Access Compliance Report

Public Rights-of-Way

(Curb Ramps)

Intersection ID: 19799	Main Street: SHARON_RD	Cross Street: COLONY_RD	Location: W
ADA ID: 8D1EFAE1841E	Ramp Type: PerpDiag	Initial Pass/Fail: Fail	Overall Compliance: No
Severity Score: 8.75			
Codes/Mitigation Info/Possible Solution		Field Measurements/Component Compliance

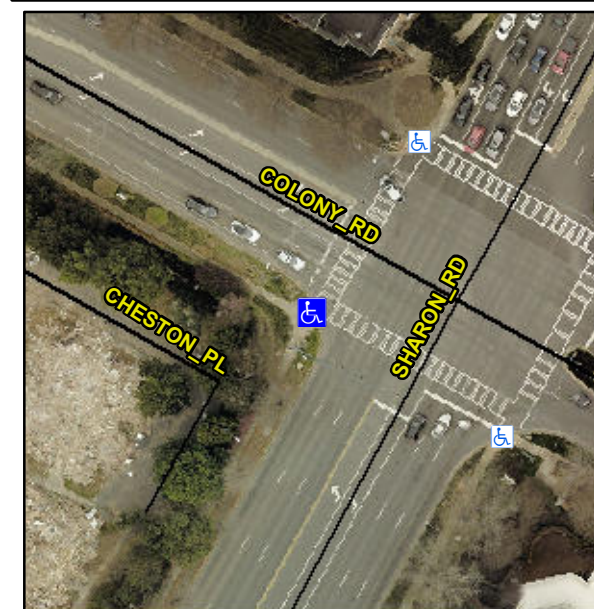
Not Found, R304.5.1

Compliance	Description	Data	Compliance	Description	Data
N/A	Ramp Length (in)	96.0	Yes	Ramp Slope (%)	7.5
No	Ramp Width (in)	43.0	Yes	Ramp XSlope (%)	0.6
N/A	Flare Type LT	N/A	N/A	Flare Type RT	N/A
N/A	Flare Slope LT (%)	N/A	N/A	Flare Slope RT (%)	N/A
N/A	Flare Traversable LT?	N/A	N/A	Flare Traversable RT?	N/A
N/A	Landing Length (in)	N/A	N/A	DWS Provided?	N/A
N/A	Landing Width (in)	N/A	N/A	DWS Contrast?	N/A
N/A	Landing Slope (%)	N/A	N/A	DWS Length (in)	N/A
N/A	Landing X Slope (%)	N/A	N/A	DWS Full Width?	N/A
N/A	Landing Curb? (Y/N)	N/A	N/A	DWS Offset (in)	N/A
N/A	Shared Landing?	N/A			
N/A	Gutter Ponding?	N/A	N/A	Gutter Slope (%)	N/A
N/A	Gutter Lip Ht (in)	N/A	N/A	Gutter X Slope (%)	N/A
N/A	Painted X Walk1?	Yes	N/A	Painted X Walk2?	Yes
	X Walk 1 Direction	To SE		X Walk 2 Direction	To NE
N/A	X Walk 1 Width (in)	120.0	N/A	X Walk 2 Width (in)	112.0
	X Walk 1 Slope (%)	4.0		X Walk 2 Slope (%)	2.1
	X Walk 1 X Slope (%)	1.7		X Walk 2 X Slope (%)	3.4

Remove & Replace Curb Ramp With Two New Directional Ramps or Equivalent.
